**P22-19**  
**Hotel Redevelopment**  
**REVISED**

Property Owner: Legacy Hotel of Medina LLC  
Applicant: Jim Gerspacher  
Location: 253 and 257 South Court Street  
Zoning: C-2 (Central Business)  
Request: Revised Conditional Zoning Certificate and Site Plan approval for the construction of a hotel

The current application revises the footprint and height of the hotel building, updates building elevations, and provides greater detail. In addition, the proposed hotel incorporates a first floor restaurant, four stories of hotel rooms, a partial fifth story with a rooftop lounge, and a small one-story area located at the rear of the building for deliveries. The proposed revision does not alter the previous approval of P24-09.

**1 PLAN** ROOF PLAN OUTLINE AND HEIGHTS  
1" = 20'-0"

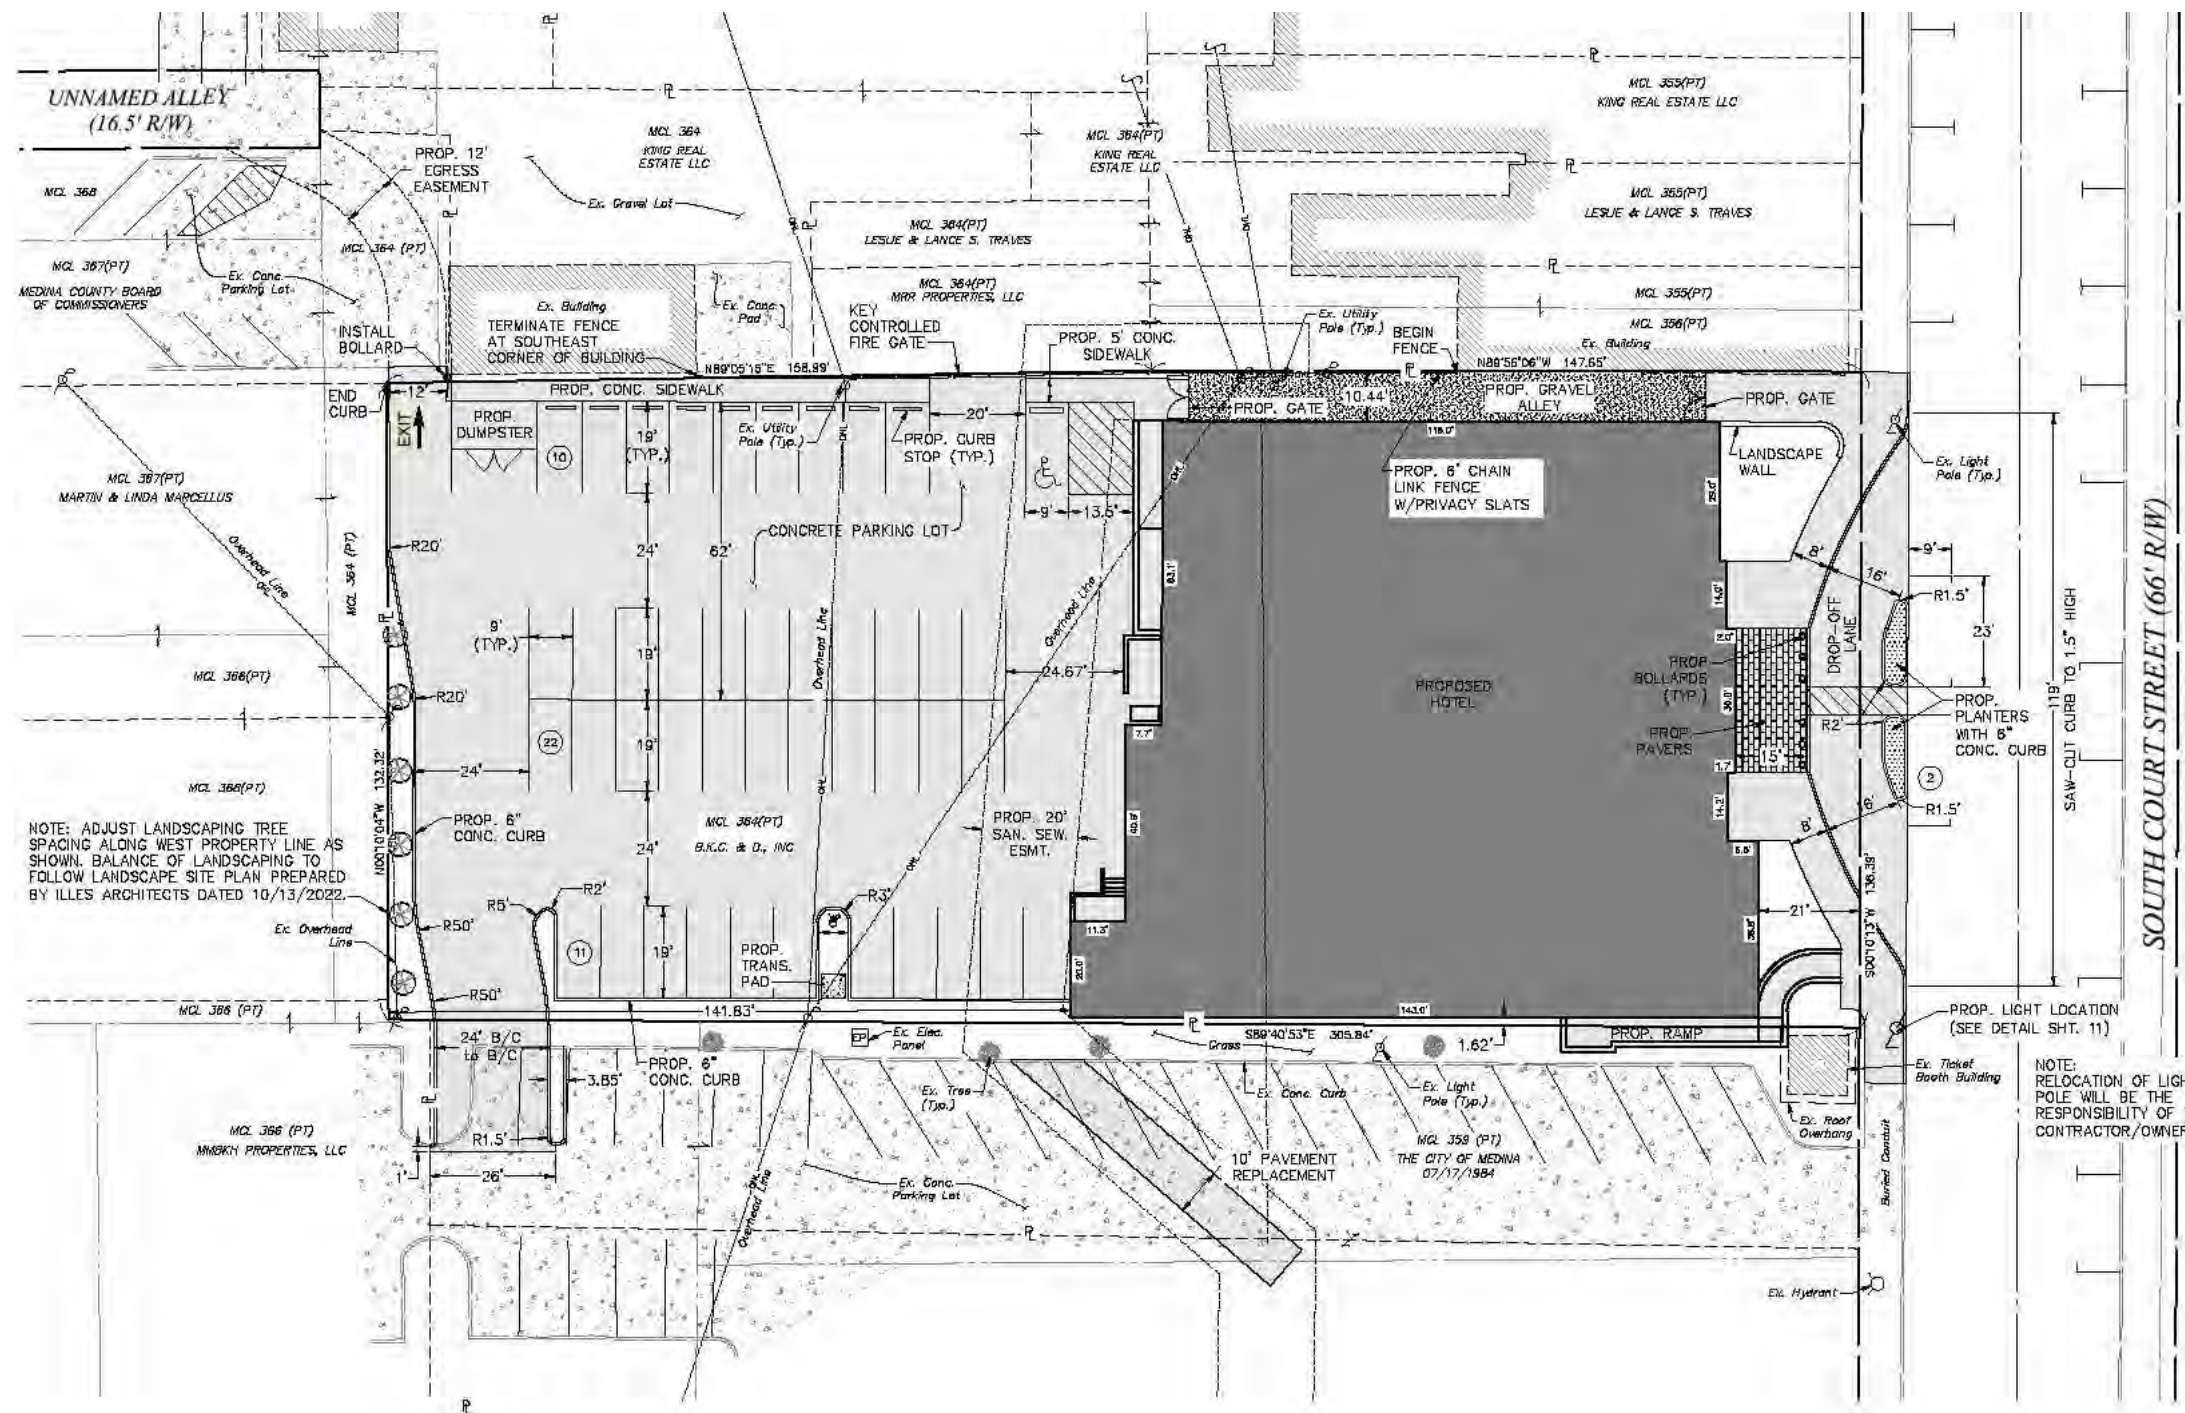
**Building Height** – The effective building height of 55 ft. was previously approved by the Planning Commission, which can approve a building height up to 60 ft. The overall effective height of the building has increased by 6 ft. to sufficiently accommodate mechanical components. The effective height of the revised building is 61 ft., which is the roof line of the building. Decorative architectural features that do not have functional interior area above this height are not included in the effective height of the building.

- 2- Height increase: the original approved elevations show the top of roof at 55'-0", the updated drawings show 61'-0". The additional height requested is 6'-0" higher than the previously approved plans. This increase in floor height accommodates more advanced HVAC systems than previously approved without sacrificing quality of interior spaces. Unlike the previous design, no suites will have exterior louvered grilles on the newly proposed plans. Without the new height variance, the available methods of construction are narrowed to options that are not as feasible and accommodating mechanical duct work becomes difficult.

The mansard roof was previously approved at 66'-8", the proposed is at 71'-0". This is purely an architectural feature that gives the hotel its historical character and is visible on S Court Street from all sides. The added height is not being used to generate profit to the developer(s).

**1 PLAN** PRELIMINARY SITE PLAN - ORIGINAL  
1" = 40'-0"

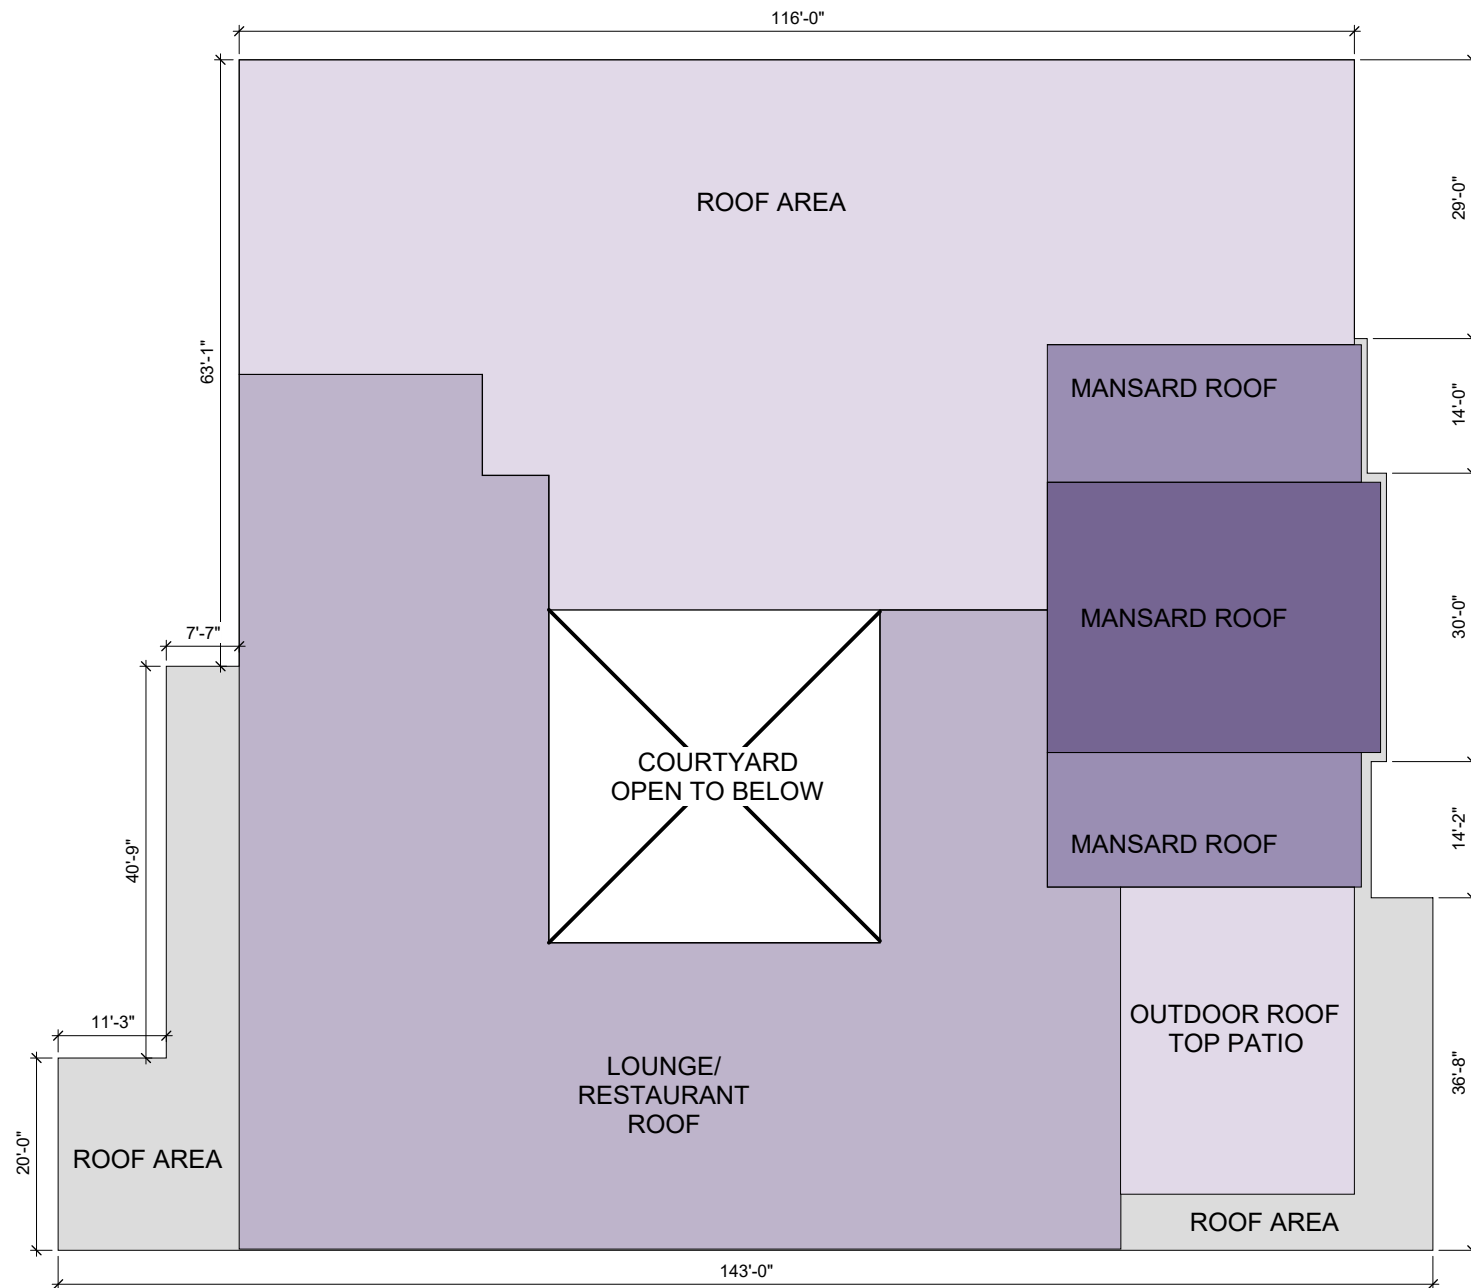
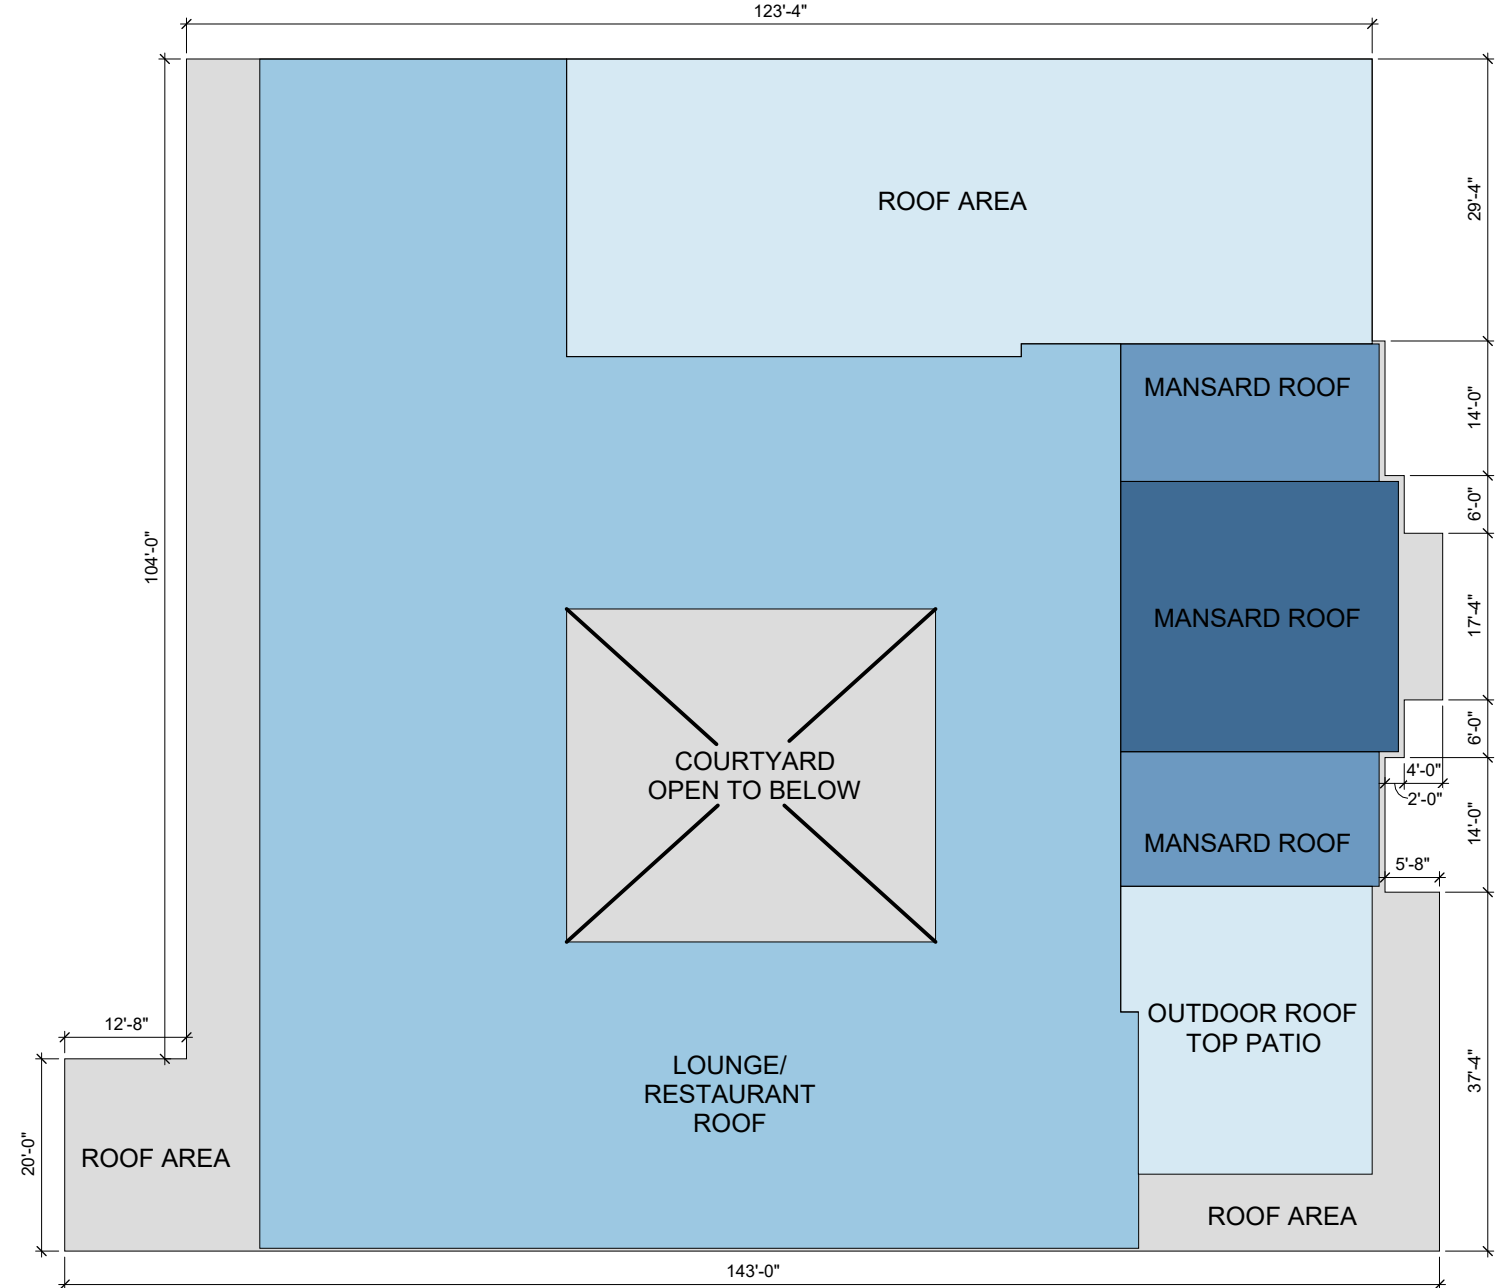
**Maximum Building Footprint** – The previously approved building contained an open courtyard in the center of the entire building. The proposed building’s footprint has increased due to the removal of the courtyard on the first floor and modifications to the east and west sides of the building. The open courtyard remains on all other floors of the building and the width of the building adjacent to South Court Street remains unchanged. The applicant has provided a detail of the changes in the building footprint on the “Site Plan and Building Footprint Original” page.

- 1- Footprint increase of 3,229 sf: Previously approved footprint was approximately 12,784 sf and proposed is 16,013 sf.

While there are minor changes to the perimeter dimensions, the square footage increase is largely due to the infill of the courtyard on the first floor. The courtyard remains a feature in the project accessed by guests on the second floor. The exterior perimeter of the hotel has grown negligibly, and it would be nearly impossible for someone to see that increase from outside the hotel. Please see below a snippet showing both footprints overlapped (blue is original footprint – gray is updated)
